ORIGINATION FORM

Proposed Revisions to a Standard Plans Index (Please provide all information — Incomplete forms will be returned)

Index Number: 455-060

Index Title: 60" Prestressed Concrete Cylinder Pile

INDEX
455-060

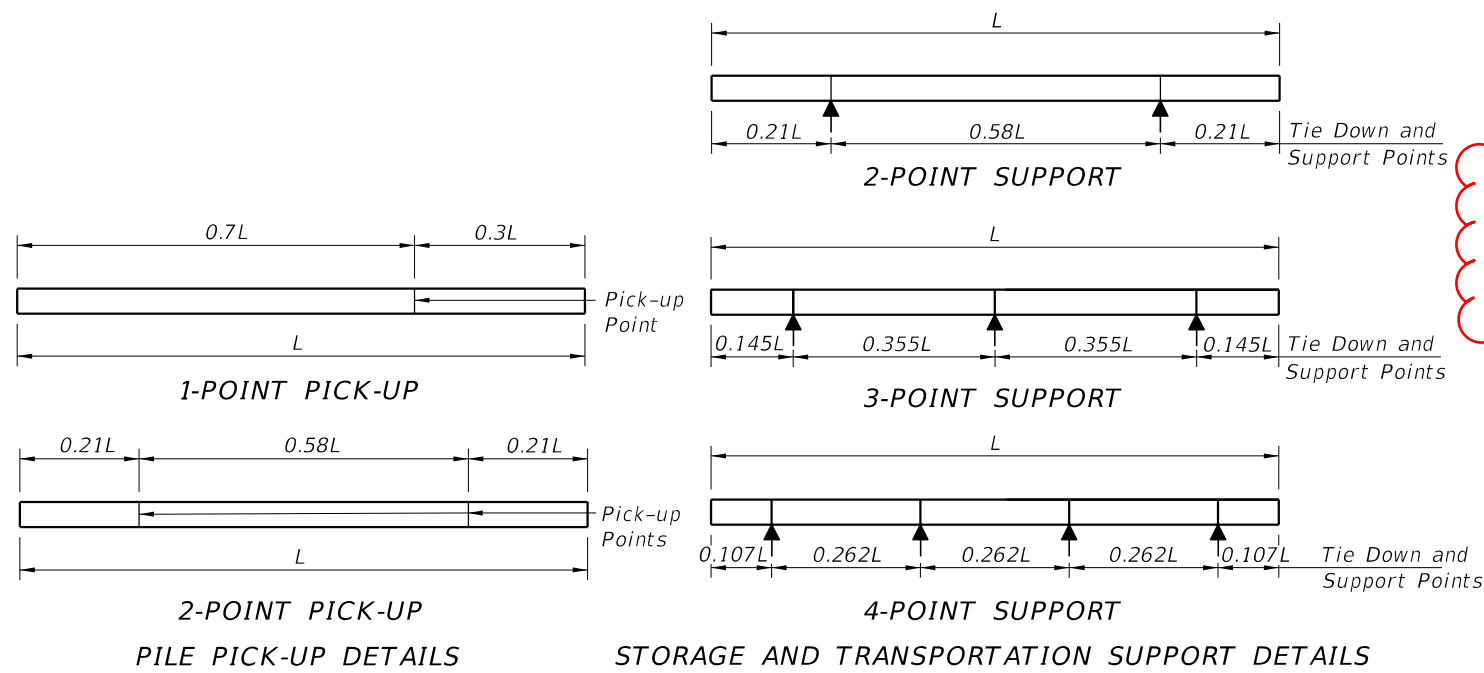
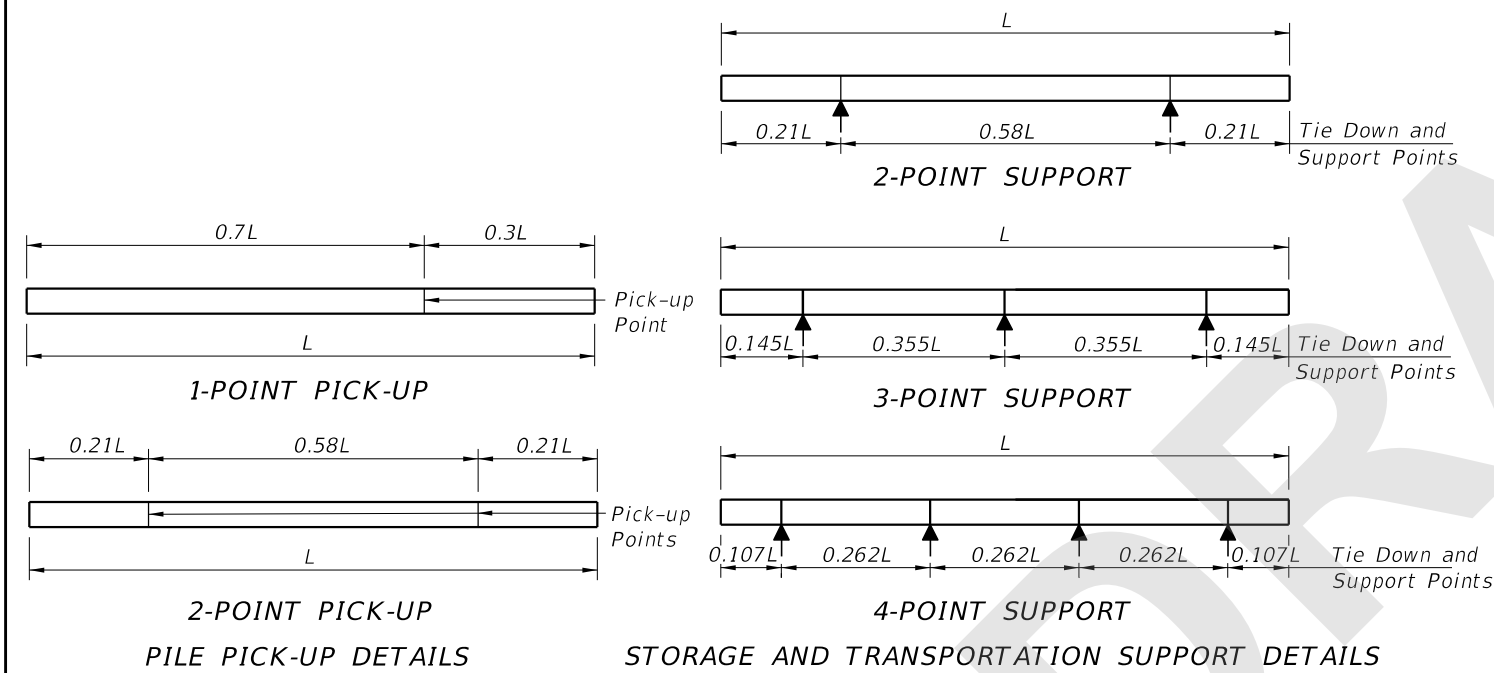
Change Silica Fume, metakaolin or ultra-fine flyash to Highly Reactive Pozzolans

Specification changed to fit silica fume, metakaolin and ultra-fine flyash under Highly Reactive Pozzolans

- Work this Index with the Pile Data Table in the Structures Plans.
- Concrete:
 - Piles: Class V (Special)
 - Splice Collar: Class IV
 - ~~Silica Fume: See "GENERAL NOTES" in the Structures Plans for locations where the use of silica fume, metakaolin or ultra-fine flyash is required.~~

Highly Reactive Pozzolans

- Work this Index with the Pile Data Table in the Structures Plans.
- Concrete:
 - Piles: Class V (Special)
 - Splice Collar: Class IV
 - See "GENERAL NOTES" in the Structures Plans for locations where the use of Highly Reactive Pozzolans is required.
